MFN 08-172

Docket No. 52-010

Subject: Response to Portion of NRC Request for Additional Information Letter Nos. 129 and 153 Related to ESBWR Design Certification Application – Human Factors Engineering - RAI Numbers 18.9-2 S01, 18.11-7 S01, 18.11-19 S01, 18.11-23 S01, 18.11-24 S01, 18.11-26 S01, and 18.11-29 S01

**Response to Portion of NRC Request for Additional
Information Letter Nos. 129 and 153 Related to
ESBWR Design Certification Application**

Figure 1

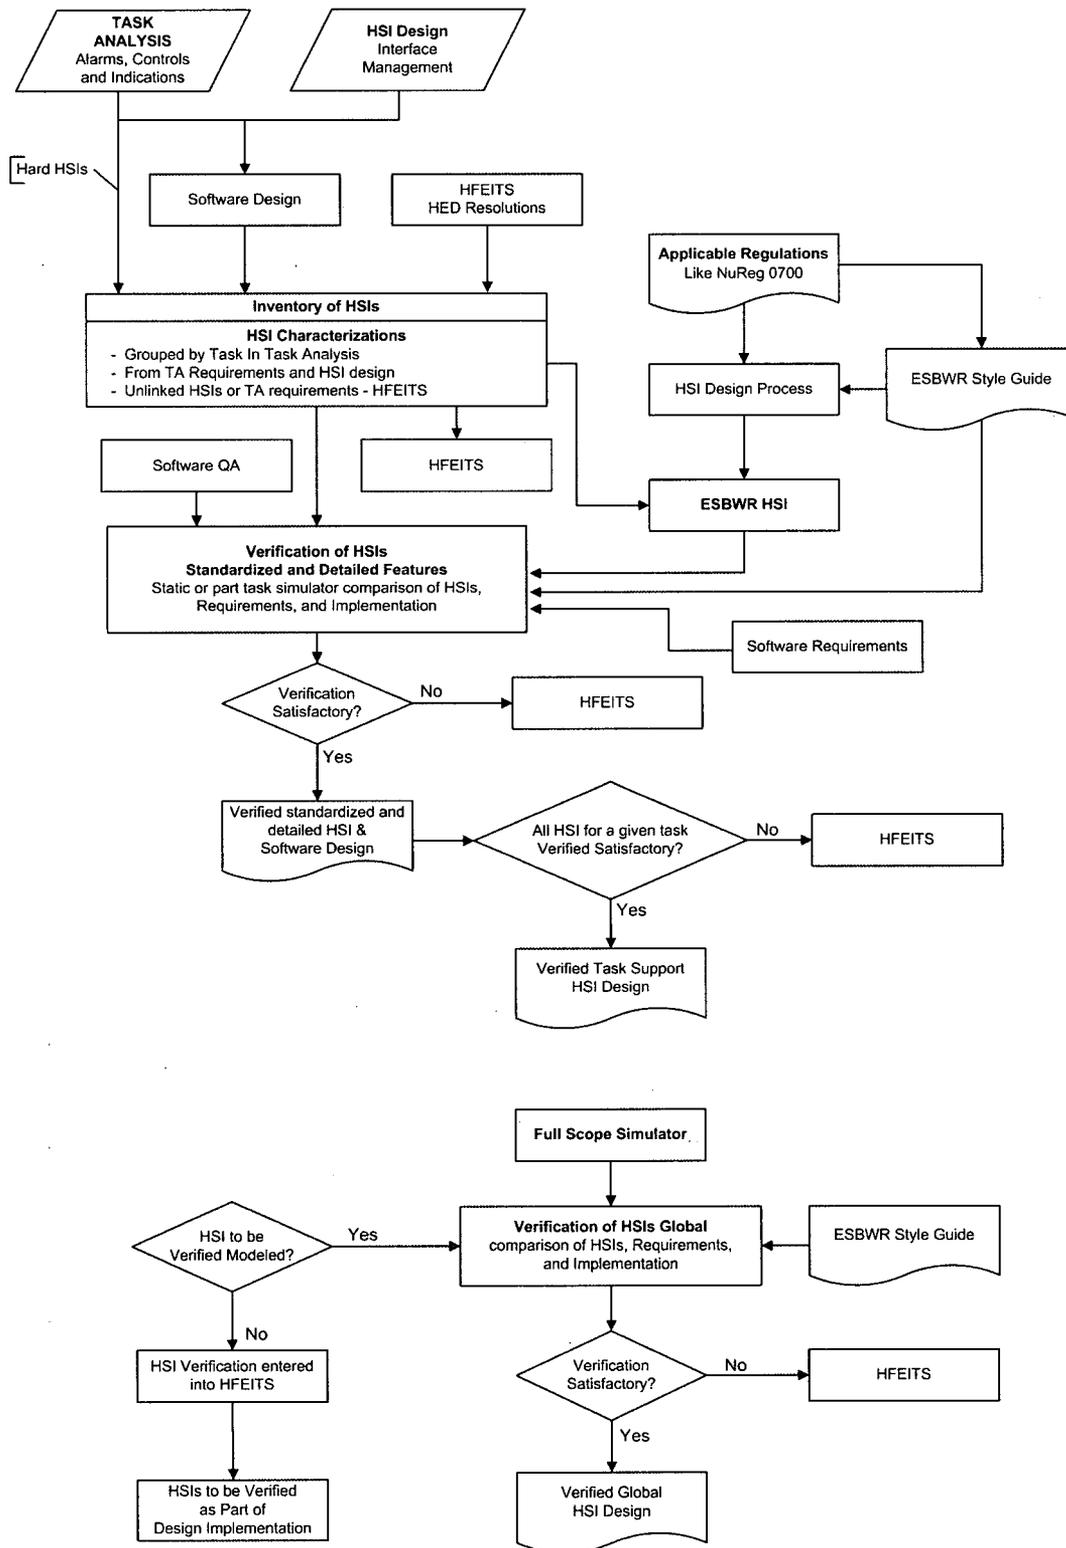
In the original RAI, the staff requested clarification as to what criteria were to be used in task support verification. GEH's response referred to their response to RAI 18.11-5. The staff followed up indicating that RAI response addresses the criteria for selecting tasks. This original RAI requested clarification of the criteria to be used to evaluate the Human-Systems Interfaces (HSIs) that support tasks. However, the material is unchanged in NEDO-33226, Rev. 1. Thus the RAI remains open. Please provide such clarification.

One example of the "uniformity of design" principle is the use of color coding across the HSI resources and within a given resource. Guidelines and specifications that define the use of colors are provided to ensure a consistent application.

LTR NEDO-33276, Rev 1 will be revised with the inserted text provided above. The attached Figure 1 will also be inserted.
